# **HATFIELD BOROUGH PLANNING COMMISSION**

**September 23, 2024**

**3. Hatfield Walk, 23 N. Main Street,  
Land Development Presentation**

RE: **Hatfield Walk Townhomes (23 N. Main St.)**  
Land Development Review Letter 1  
Bursich Project No: HAT-01 / 228290

Drawing No. **C2.0**

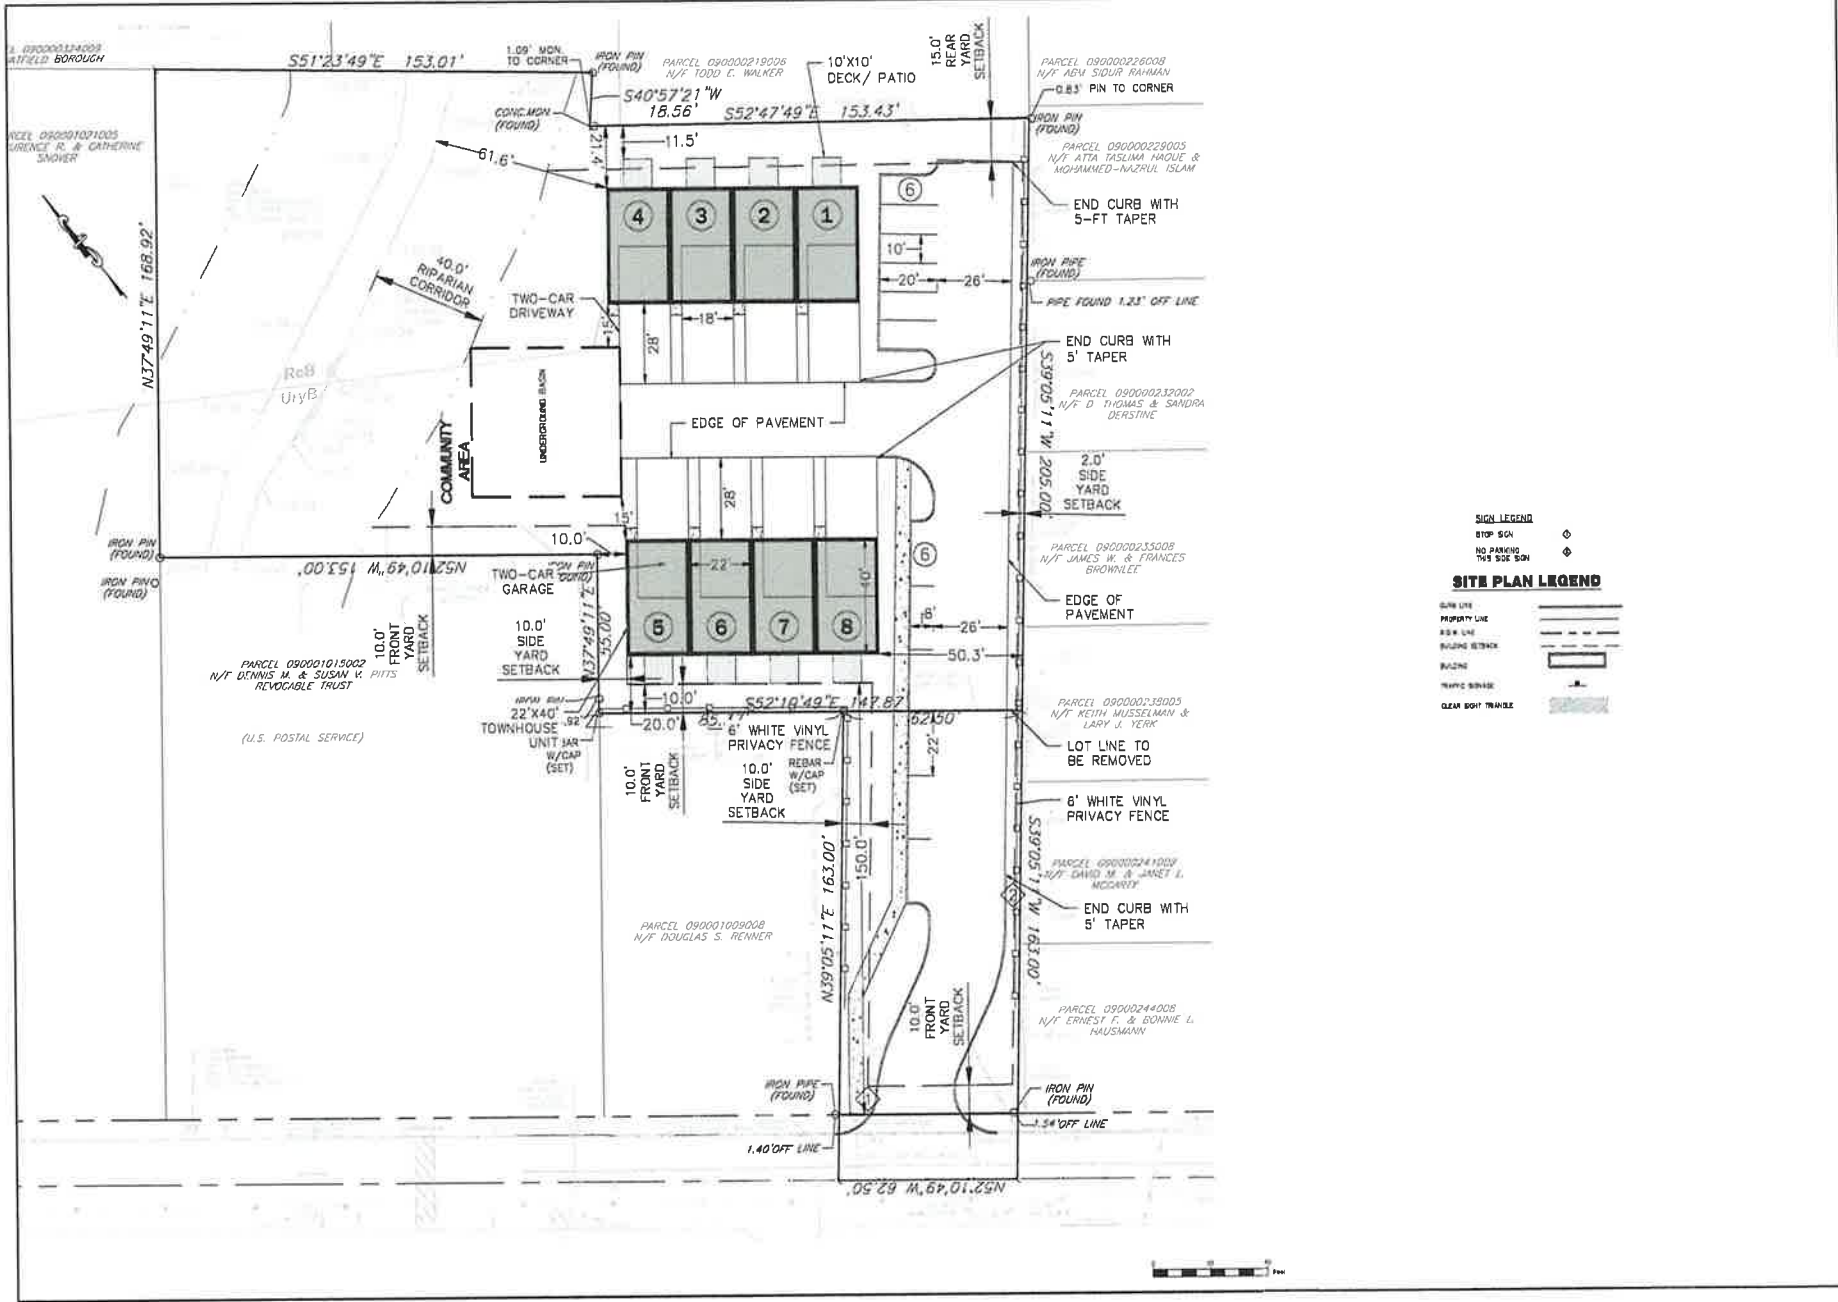
1. §22-305 & §22-307 – The plans shall be revised to include or clarify the following information:
- A. The parcels subject to the application shall be labeled on the Record Plan, and the Lot Line to be Removed shall be more clearly labeled. Site Plan Note 3 on sheet 1 shall include both parcels.

- E. The bounds of the new site shall be labeled to the right-of-way line.
  - F. The Combined Lot Area in the Lot Area Calcs. table on sheet 1 shall indicate “Net”.

- Q. The proposed grades shall be shown on the plan view on sheet 14.
2. §22-410.E – The clear sight triangle shall be labeled on the plans, and all existing and proposed features within the sight triangle shall be labeled.

7. The plans shall clarify if the site will contain community or individual mailboxes.
8. Site Plan Note 20 on sheet 1 shall include sheets 1, 3, 6, and 7 to be recorded. These sheets shall also be noted to be recorded on the Drawing List.

9. Site Plan Note 9 on sheet 1 shall clarify that each unit will be responsible for trash pickup at their driveways rather than a community dumpster.
10. We recommend a backup / turn-around area be provided in the access driveway for Unit 4 to back out of their driveway.

14. The proposed crosswalk and stop bar on the Detail Sheet shall be illustrated on the plans.
15. Grading Note 6 on sheet 5 shall be revised to resolve the conflict in the horizontal to vertical slopes.

FIGURE 1

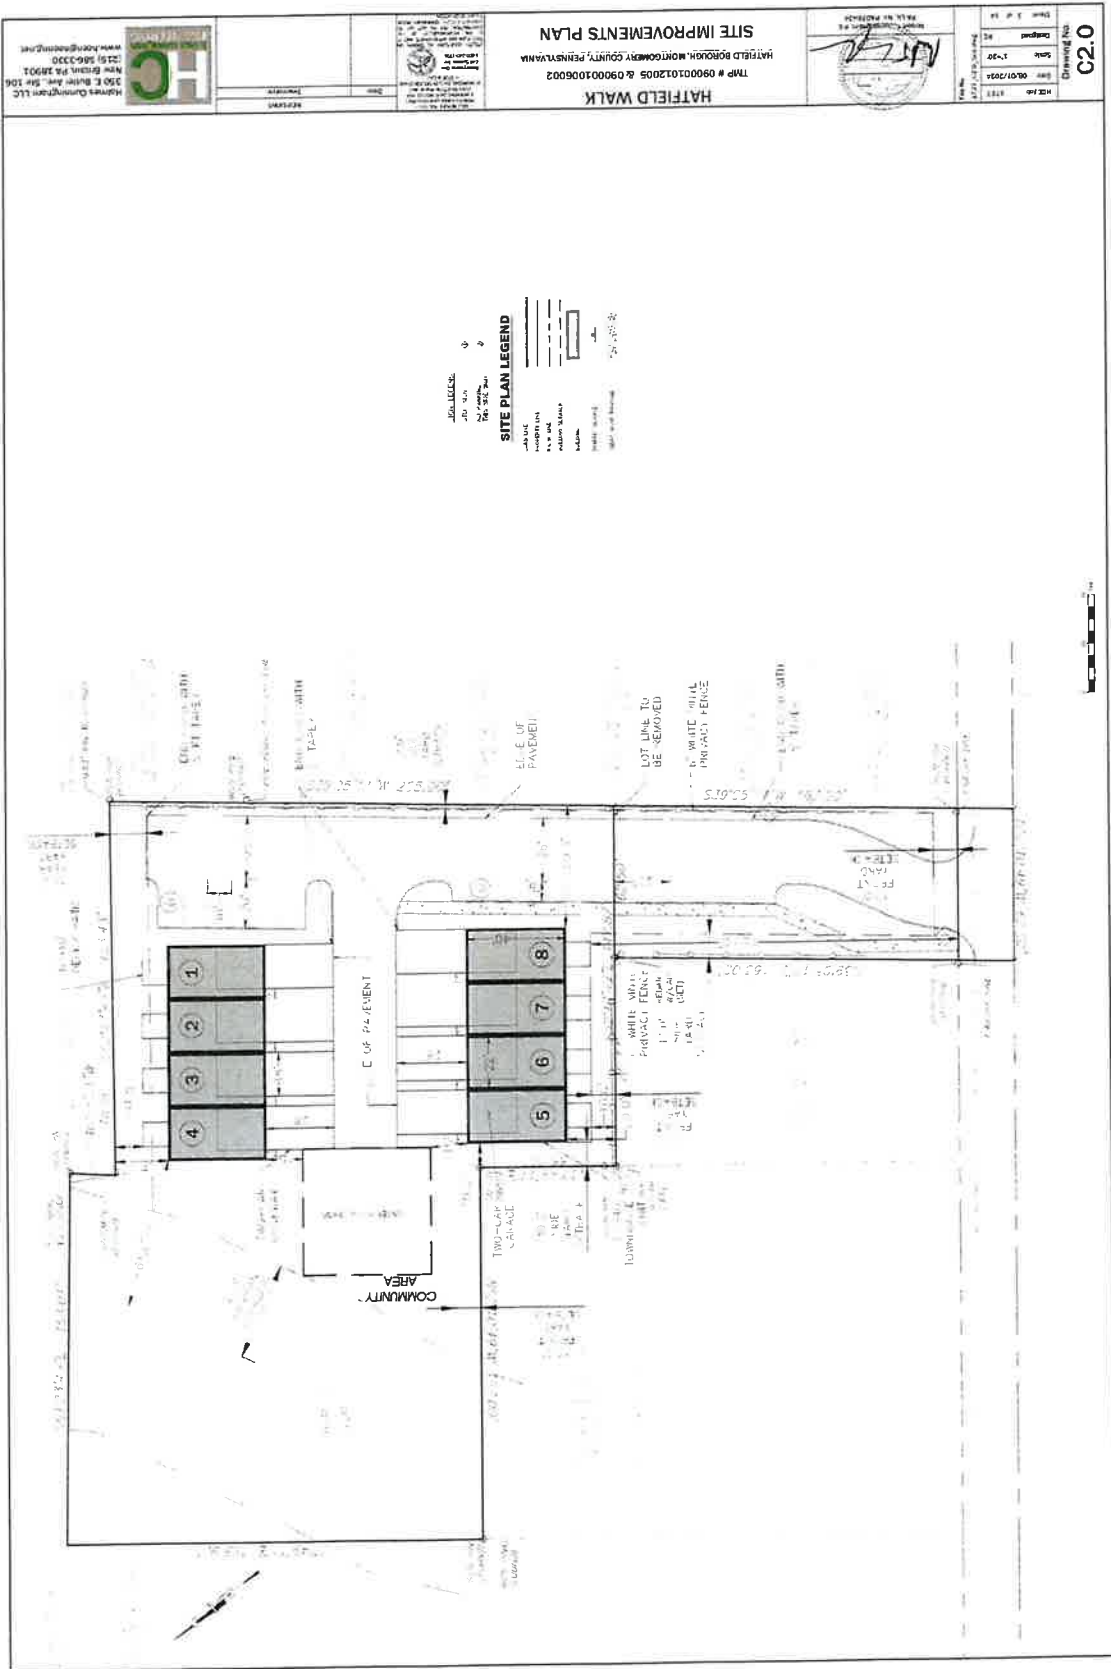
2. The site access study should be revised to include a traffic analysis of the intersection of Main Street and Broad Street. The intersection currently experiences delay during the commuter peak hours and the queuing along Main Street may impact the operation of the site driveway during the commuter peak hours. A gap study along North Main Street at the proposed site driveway location should be conducted if necessary to confirm that there are an adequate number of gaps in the North Main Street traffic stream for vehicles to safely enter and exit the site.
